ENGINEERING CHANGE NOTICE — ECN-2025-044

REDLINE MARKUP — Connector Plate Assy PN-4457 Rev C → Rev D

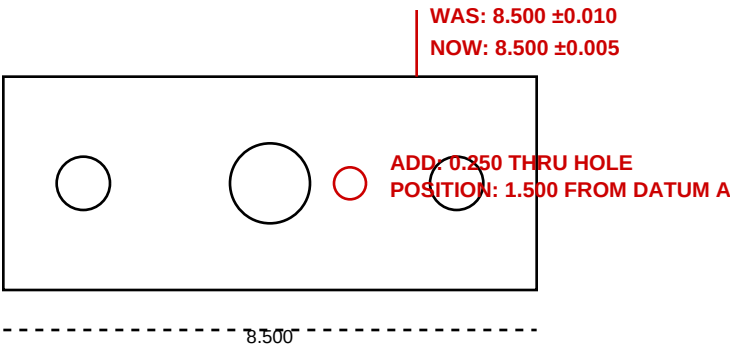
REV D CHANGES:

- 1. TIGHTENED GENERAL TOLERANCE FROM ±0.010 TO ±0.005
- 2. ADDED THRU HOLE FOR WIRING HARNESS ROUTING
- 3. UPDATED BOM: ADDED GROMMET MS35489-30 (QTY 1)
- 4. ADDED NOTE 4: BREAK EDGE OF NEW HOLE 0.015 MAX
